AL BASRAH OIL TERMINAL
BASRAH, IRAQ

SIGIR PA-06-080
APRIL 26, 2007

SUBJECT: Report on the Al Basrah Oil Terminal, Basrah, Iraq (Report Number
SIGIR PA-06-090)

Figure 15. Illustration of a fully inflated life raft (note life raft does not appear to hold 20 occupants)

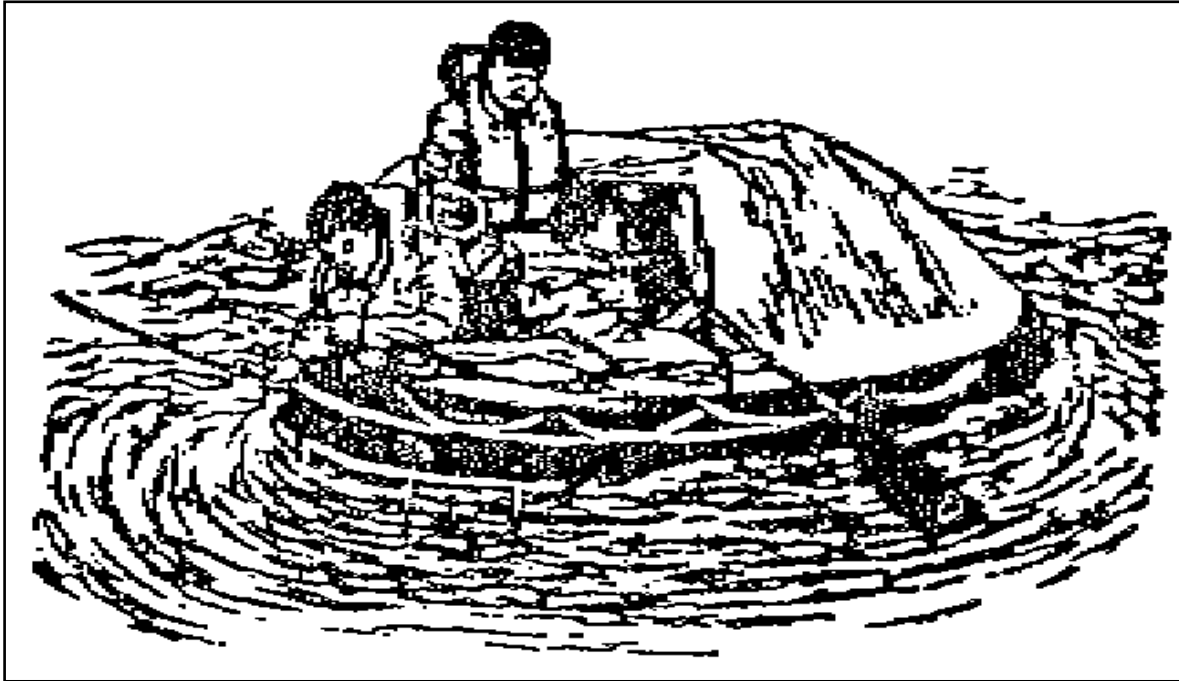
The information provided by the manufacturer did not include a photograph of the entire life raft, instead relying solely upon an illustration (Figure 15). The only photographs available of the life raft were provided by the company that inspected the life rafts. However, full length views of the front and rear of the life raft were not provided; instead only various angles of the life raft were available. Site Photos 22 and 23 provide an interior and exterior view of the life raft, respectively.

GRD representatives have stated the "the life rafts are totally enclosed," which complies with PIJV's specification that the "life raft shall have a canopy to protect the occupants from exposure..." The life raft chosen is not completely enclosed (Site Photos 24 and 25) and will not provide the occupants any protection from a major fire. In addition, GRD representatives stated that the life rafts are a "covered type design that would protect life raft from waves during heavy seas." According to GRD representatives, sea waves of approximately 15 feet are not uncommon for the ABOT area. We have concerns that this particular life raft, which is not fully enclosed and made of a soft skin cover, would survive long in such sea conditions.

Site Photo 22. Interior of life raft

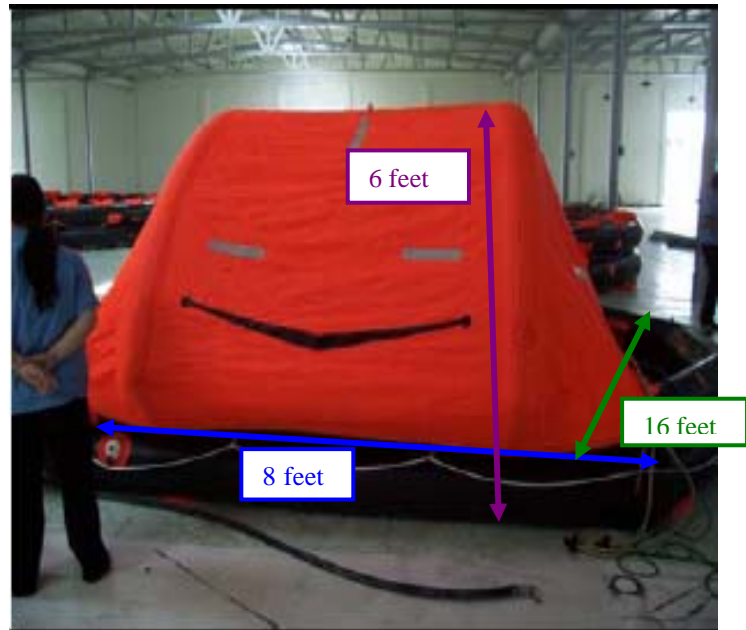
However, neither the Technical Inspection nor the manufacturer's documentation addressed the issue of the maximum cumulative amount of weight of 20 people or the issue of the buoyancy of the life raft with 20 people on board. Without this information, it is questionable how the manufacturer determined each life raft has a carrying capacity of 20 people. GRD representatives, when asked these questions, stated that "GRD does not know if such tests were performed for this particular order placed by PIJV." The manufacturer's documentation indicated each life raft is approximately 16 feet in length, 8.5 feet wide, and the canopy is 6 feet high (Site Photo 23). This appears to be an extremely tight fit for 20 people.

Site Photos 24 and 25. Fully inflated life raft, which is not fully enclosed

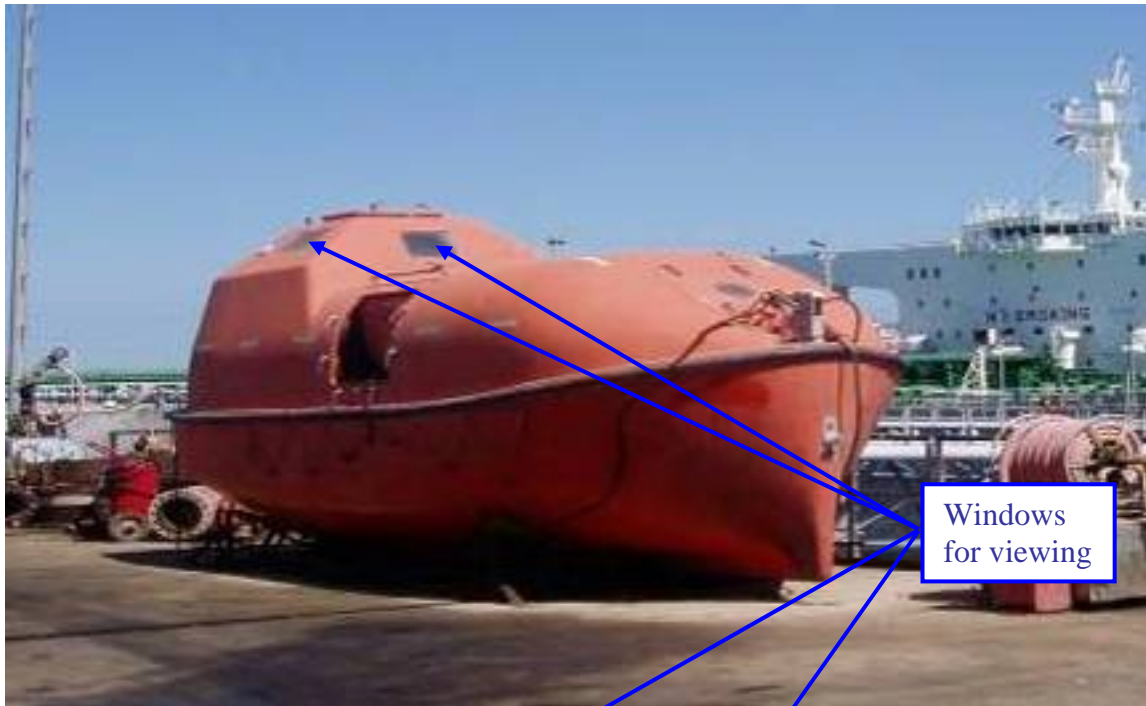
According to GRD Oil representatives, the standard for life raft is SOLAS and the life rafts procured comply with it; therefore, the life rafts are acceptable. However, this project was to provide "emergency and/or fast rescue boats" to be used in the "event of an emergency." The emergency described in PIJV's November 2005 PSSR was a "major fire." In the event of a major fire on the terminal, we believe the life rafts would not be an adequate means of escape. The existing escape capsules offer the best opportunity for survival not only because they are fully enclosed but they also provide front, rear, and side viewing to navigate through an ocean of burning oil (Site Photos 26 and 27).

Figure 16. Current location of the two existing evacuation escape capsules and eight life rafts

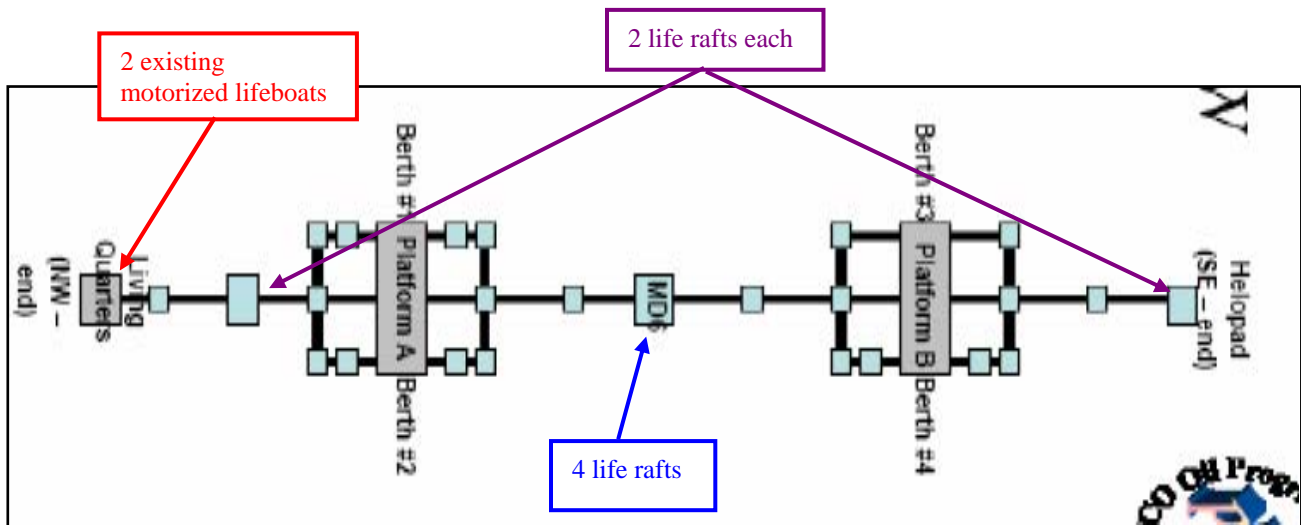
According to GRD representatives, the eight life rafts were installed at the helipad, MD6, and MD2 (Figure 16). Currently, there are no known muster points for an emergency evacuation on ABOT; therefore, we cannot determine if the life rafts were installed at the correct spots.
